Re: Clarksburg Town Center
Phase 2D, Block N - S.F. Lots 1 – 3, 15 – 17, 26 -34, 35 -38 and 52 – 55
Phase 2D, Block K – S.F. Lots 9 – 11
Phase 2D, Block N – T.H. Lots 9 -14, 18 -25

The following are the lot specific guideline requirements as they relate to your single family and townhouse products in Phase 2D:

Re: Clarksburg Town Center
Phase 2A and B - Design Guideline Requirements

Re: Clarksburg Town Center
Phase 2 and Phase 1A - Design Guideline Requirements

OPTION D
Flat Fence
Flat Wide Picket
45 degree mitered
post

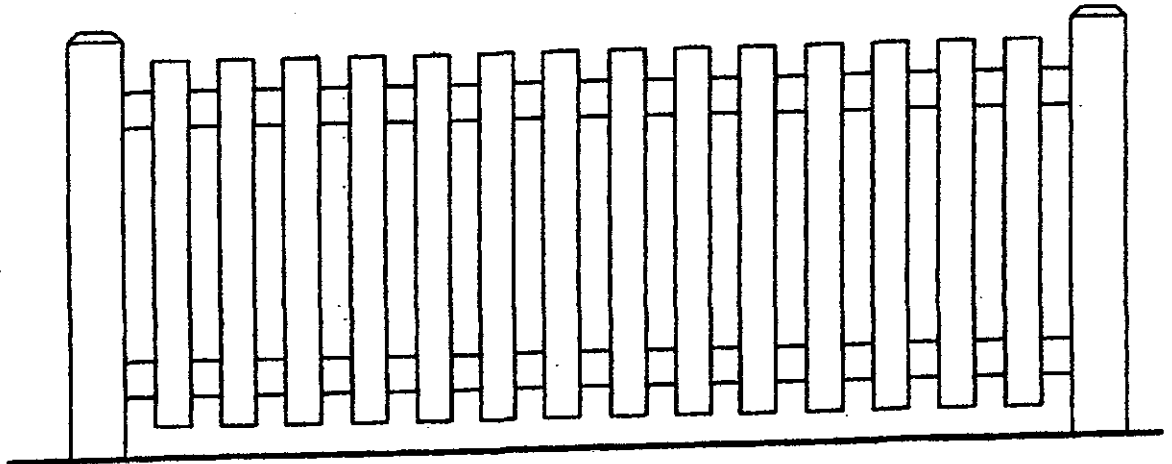
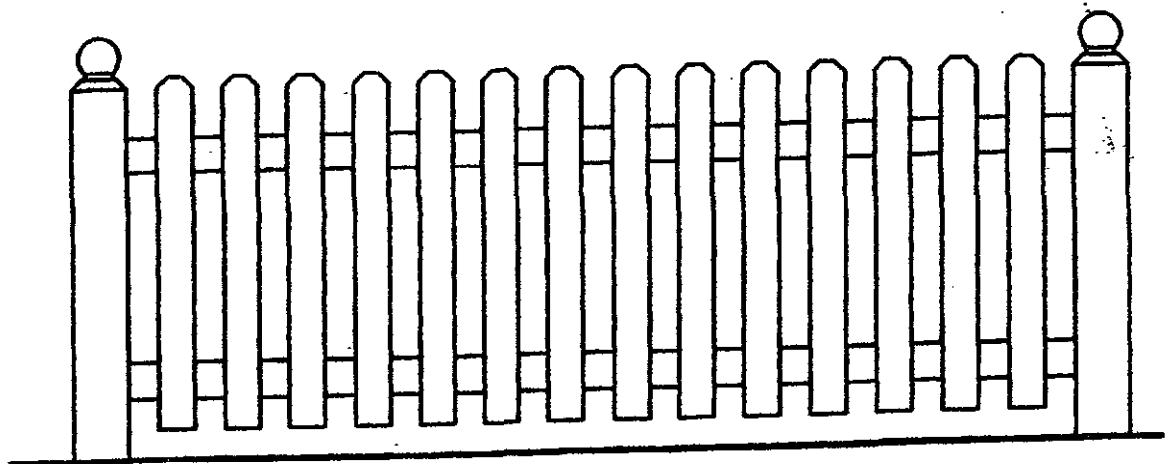
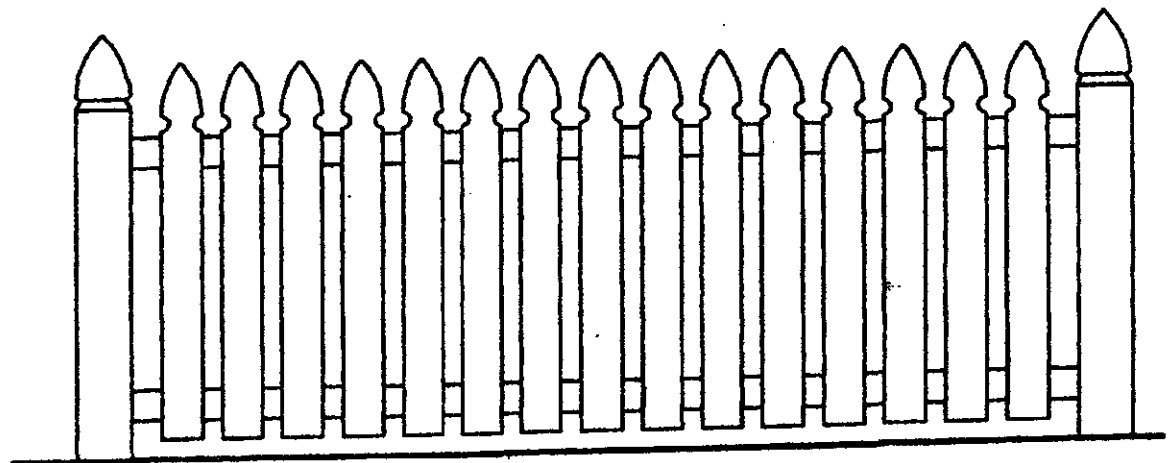
- Wood picket fencing painted Clarksburg White is required along the entire front property line of lots 22 - 27 and 28 - 33, as well as at the side yard of lot 33 connecting the rear of the unit to the garage. The picket fence selection shall be the same Option (D) and height (36") that was selected for the single family lots 18 - 21.

OPTION D :
Flat Fence
Flat Wide Picket
45 degree mitered post

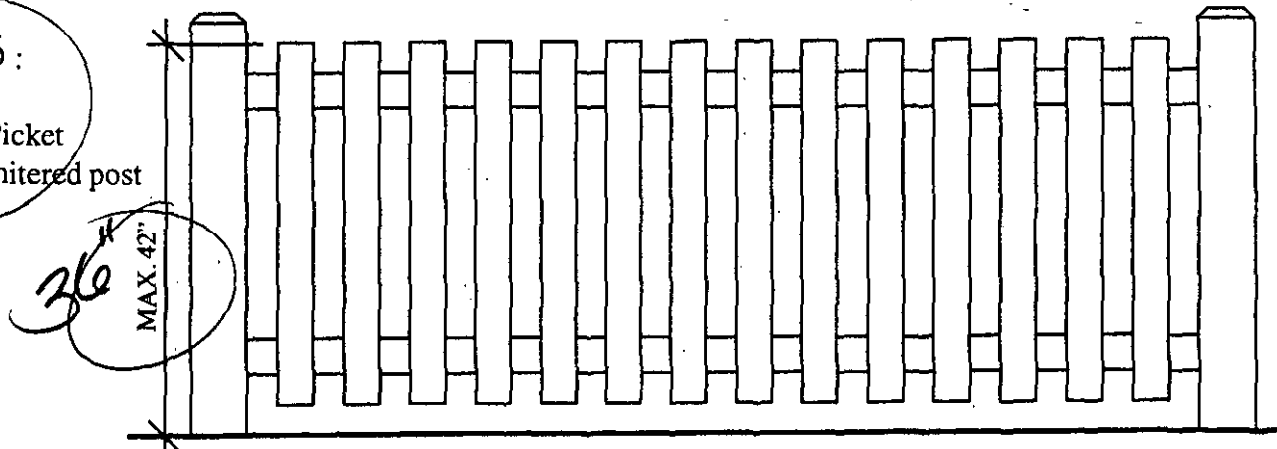
We have selected Wood Picket Fence "D" from the guidelines at 42" tall - Flat Fence; Flat Wide Picket; 45 degree mitered post.

We have selected Wood Picket Fence "D" from the guidelines at ~~42"~~^{36"} tall - Flat Fence; Flat Wide Picket; 45 degree mitered post.

Hi Nancy - We'll definitely take the 36" height instead of the 42".

The Option D picket fence is fine, however if you think it is more appropriate to install at 36" height, that would be acceptable to the NCS. Just let me know.
